UNITED STATES PATENT AND TRADEMARK OFFICE

APPLICATION NO.	FILING DATE	FIRST NAMED INVENTOR	ATTORNEY DOCKET NO.	CONFIRMATION NO.
10/718,425	11/20/2003	Steven Ryals	BE1-0031US	9644

DETAILED ACTION

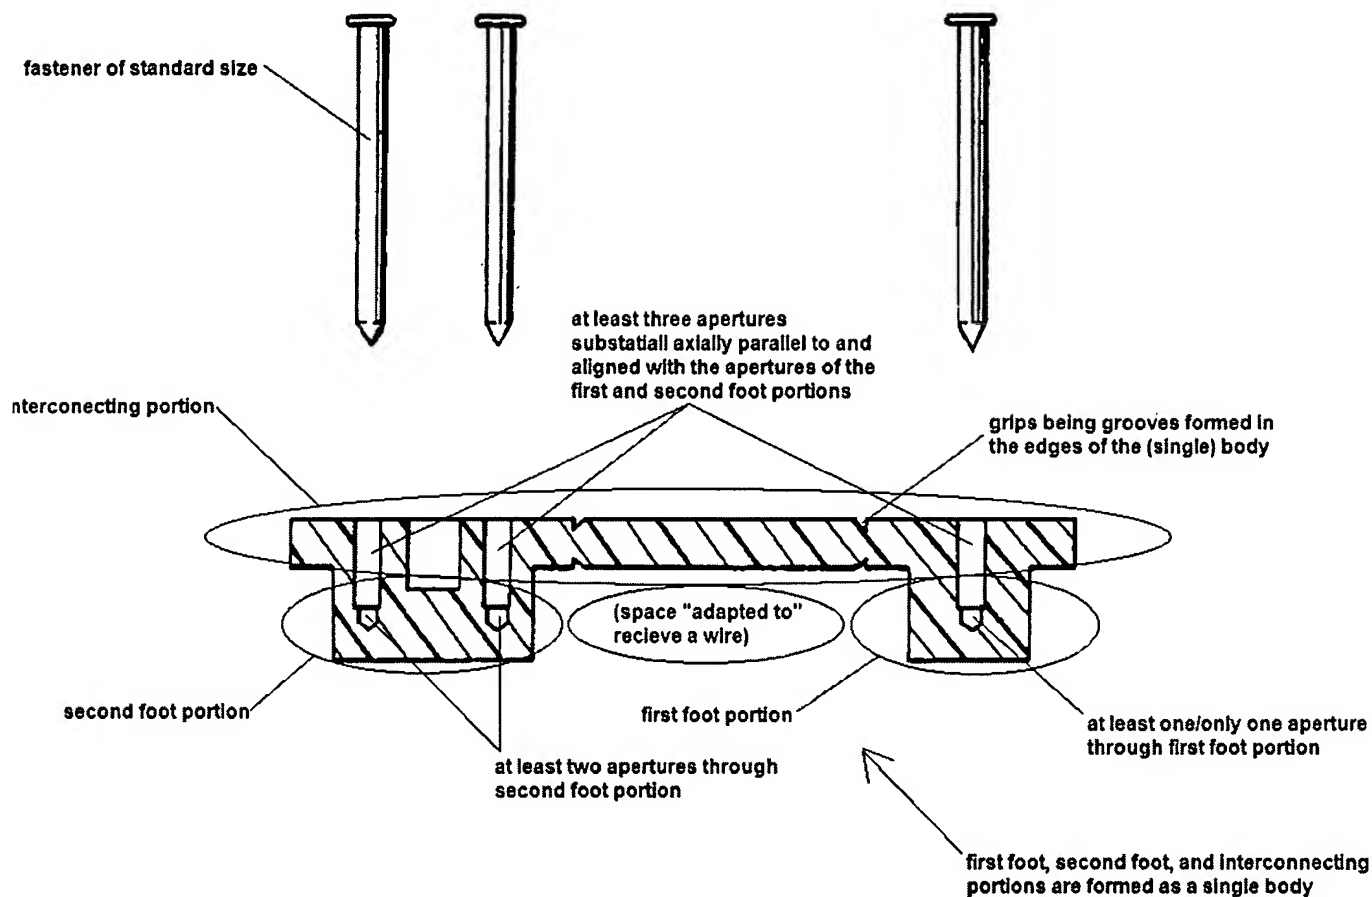
[8] Claims 9-14 are rejected under 35 U.S.C. 102(b) as being anticipated by Larsen US-5,314,160.

In short, Larsen teaches an apparatus having a body comprising a first foot portion (10) having at least one or only one aperture (38), a second foot portion (12) having at least two apertures (18, 20, 46), and an interconnecting portion (14, 23, 34, 54) that shares at least three apertures which are "axially parallel to and aligned with the apertures of the first (10) and second (12) foot portions"

Ruehl US-4,582,288

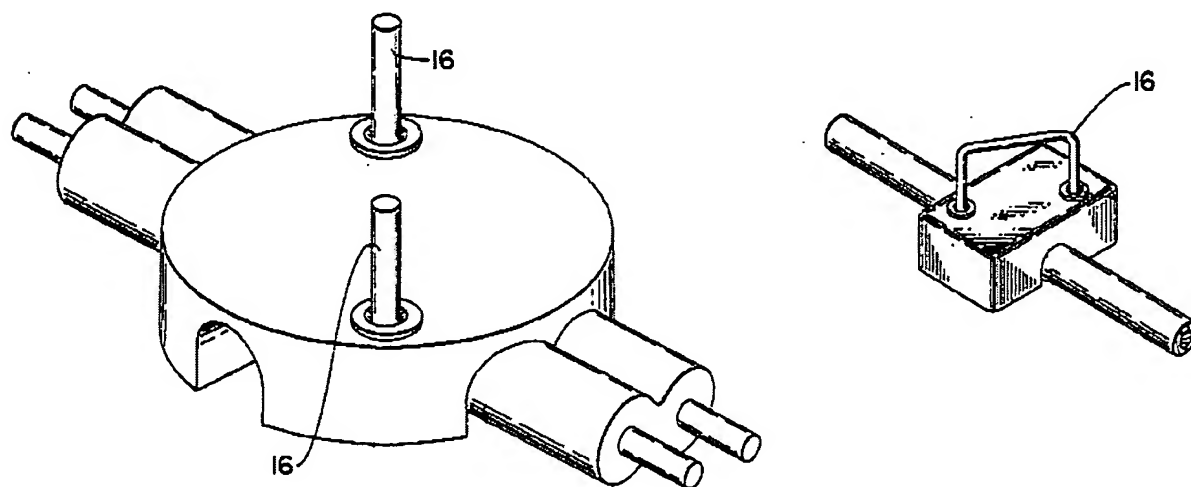
In short, Larsen teaches an apparatus having each and every limitation of claims 17 and 23-25 as discussed above, and broadly and openly states that the apertures are "complimentary to *fastening elements*, which *may* be case-hardened nails"; however, Larsen fails to disclose specifically, staples as the fastening element(s).

Ruehl suggests substituting nails for staples in an apparatus having two foot portions, an interconnecting portion, and a passage, said apparatus being adapted to receive and retain a wire.

Therefore, at the time of invention, it would have been obvious to one of ordinary skill in the art, to modify the at least one fastener taught by Larsen, to comprise a staple as suggested by Ruehl, since Ruehl establishes that a staple is an art-recognized equivalent to a nail, especially in wire protectors and retainers. Moreover, it would be advantageous to employ a staple over a nail, in order to reduce the number of working parts used to fasten the apparatus to the mounting structure.
